March 15, 2018

## Responses to Vermont Agency of Natural Resources Comments on December 2017 Draft Interim Conceptual Site Model Site Investigation Report and February 2018 Draft Conceptual Site Model Site Investigation Report

### February 21, 2018 Comments on December 2017 Draft Interim Conceptual Site Model Report

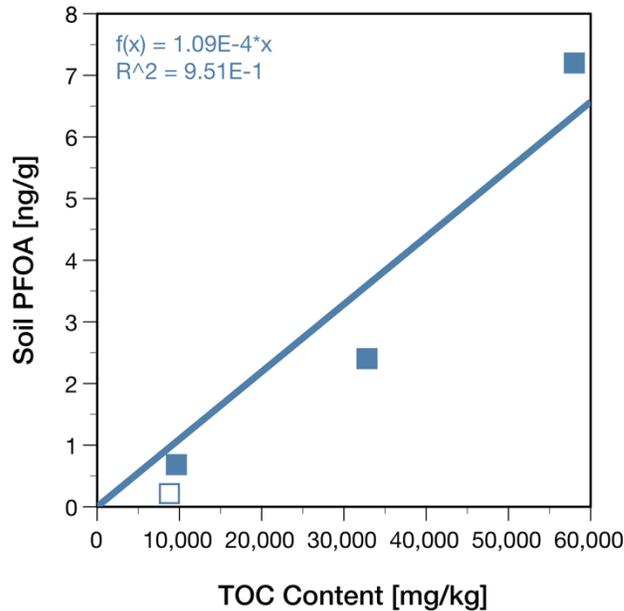
**Response:**

A revised approach to evaluating background deposition based on characteristic flushing times for surficial soils was developed to complement the background deposition analysis presented previously and to address this comment and related comments. The revised assessment is described below and discussed in detail in Section 4.4.1 and Appendix D.2 of the Final CSM SI Report.

The background parameter of interest for the complementary analysis is the background deposition rate rather than the background soil concentration. This is the rate at which PFOA is deposited on the soil surface. Unlike the emissions from the former Chemfab facility that stopped about 15 years ago, the background deposition continues to supply PFOA to the soil surfaces. This background deposition rate, in combination with the infiltration of precipitation and the retardation of PFOA by the soil, influences the PFOA concentration found in the superficial soils, *i.e.*, the upper 6 inches of the soil column. The partitioning of PFOA between the water and soil phases can be indexed by the TOC content of the soil. Under constant deposition rates and constant water infiltration rates, a pseudo-steady-state condition develops where the soil PFOA concentration is a linear function of the TOC content. Thus, a collection of soil samples that show a linear correlation between soil TOC content and soil PFOA concentrations would be indicative of a relatively constant background deposition rate and relatively constant water infiltration rate.

Surficial soil samples (upper 6 inches) collected at the four background locations located between 8 and 22 miles from the Chemfab facility showed a range of soil TOC and PFOA concentrations. As illustrated in Figure 1 below, the observed PFOA soil concentrations can be characterized as a linear function of the soil TOC content. The superficial soil samples from location BG3 had a PFOA concentration less than the Method Detection Limit (MDL) and for these samples the concentration was assumed to equal the MDL for purposes of this analysis. Because the four background locations were miles apart, the observed linear correlation between TOC content and superficial soil PFOA concentration suggests that the continuing deposition rate was spatially uniform across the region that encompassed the four background sampling locations. This continuing deposition creates measurable PFOA concentrations in surficial soils.

The time required to flush 95 percent of the initial PFOA out of the upper 6 inches of soil for the four samples were calculated using the soil TOC contents provided in Figure 1. Based on an infiltration rate of 19.5 inches/year (Barr, 2017c) and assuming that the infiltrating water initially contained no PFOA, the simulated time required to flush the PFOA from the soil ranged from about 2.6 years for a TOC of about 10,000 mg/kg, to about 8.5 years for a TOC of about 33,000 mg/kg, to about 14.9 years for a TOC of about 58,000 mg/kg. Assuming a TOC at the high end of the range measured (58,000 mg/kg) and an initial soil PFOA concentration of about 1.6 ng/g when the Chemfab emissions stopped (which is the soil concentration that is predicted near the edge of the air model domain at that time multiplied by the correction factor of 7.7 to account for differences in TOC content between the locations of the air model node and background location BG2 and the higher emission rate used in the VT ANR air quality model), the present-day maximum residual soil concentration would be less than 0.08 ng/g. This concentration is below the typical detection limit for the CSM SI analyses. The fact that there are detectable superficial soil PFOA concentrations when none should exist, based on the time required to flush PFOA last deposited at least 15 years ago, strongly supports a continuing source of PFOA. The magnitude of the measured PFOA concentrations and the distance between the four sampling locations suggest a significant regional background PFOA deposition rate.

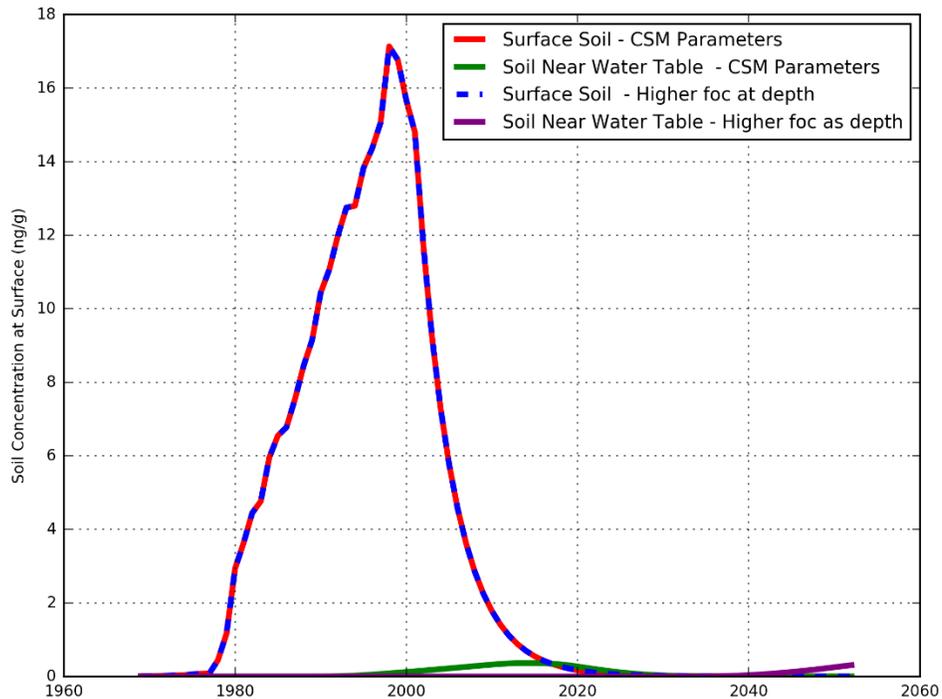
**Comment 51:** *Figure 4.16 shows a typical delay curve for the rise of surface zone concentrations over the period of Chemfab operation and fall after emissions ceased, and the resultant soil concentration at the water table as they rose to a maximum and then fell, but including a delay dependent on the assumed recharge, vertical K, and retardation factor (different for the three vertical soil zones). The foc is a major factor in determining the retardation given assumptions for bulk density, porosity and organic carbon partition coefficient. If the foc in the lower soil column is greater than assumed (0.005), then there may be more PFOA mass in the unsaturated zone and delay patterns may be different than shown. For comparison, even using the unsaturated zone assumed foc values (using bulk density of 1.86 g/cc and a porosity 0.3), the retardation factors are 86.25, 18.05, and 2.705 for the 0-10, 10-36, and >36 cm depth intervals, respectively. If the > 36 cm foc value were the geometric mean of the observed values (0.0032), the retardation factor would be 11.9. However, as pointed out above, a more realistic approach would be to provide a gradation of foc over the lower unsaturated zone model layers. This refinement to the model would make the retardation factor for this unit even greater than the ones listed above.*

**Response:** While we agree with general observation in VT ANR's comment that retention in the soil column is a function of the hydraulic and transport properties of the soil, there are several points raised by VT ANR that require revision. As described in the Draft CSM Report (Barr, 2017c), recharge rates were not assumed, they were calculated using the SWB model. The vertical hydraulic conductivity specified in the unsaturated zone modeling is for saturated material. At the average infiltration rates calculated using SWB, the soils are not saturated, therefore the simulated vertical hydraulic conductivity is much lower than the saturated vertical hydraulic conductivity (Niswonger, et al, 2006). The retardation factor for unsaturated materials depends on the water content of material, not the porosity. The water content varies throughout the model domain in proportion to the calculated infiltration rate.

Regardless, increasing the foc in the > 36 cm depth interval would decrease the simulated mass of PFOA in groundwater at any time after breakthrough occurs. For example, the figure below shows the simulated time series presented in Figure 4.19 of the February Draft CSM SI Report (Figure 4.16 of the December Draft CSM SI Report), updated to include a time series with the foc for the >36 cm interval set to 0.0032 as suggested. With a larger foc for the deeper interval, PFOA does not reach the deepest soils (and subsequently does not reach the water table) until approximately 2035, a condition that is not observed (i.e., groundwater analytical data clearly indicate that transport through the unsaturated zone is much faster).

It is also noted that if geometric mean values of foc were used to calculate retardation factors, as described in the comment, then the retardation factor for the 0-10 cm interval would drop since the geometric mean of measured values in the 0-10 cm soils is lower than the value used in the model. As discussed elsewhere, the foc values determined from CSM SI data provide a range of expected values and confirm the conceptual understanding that TOC (foc) decreases with depth. Model values of foc were adjusted during the calibration process and evaluated during sensitivity analysis. The data collected as part of the CSM SI confirm that the model uses reasonable values for foc.
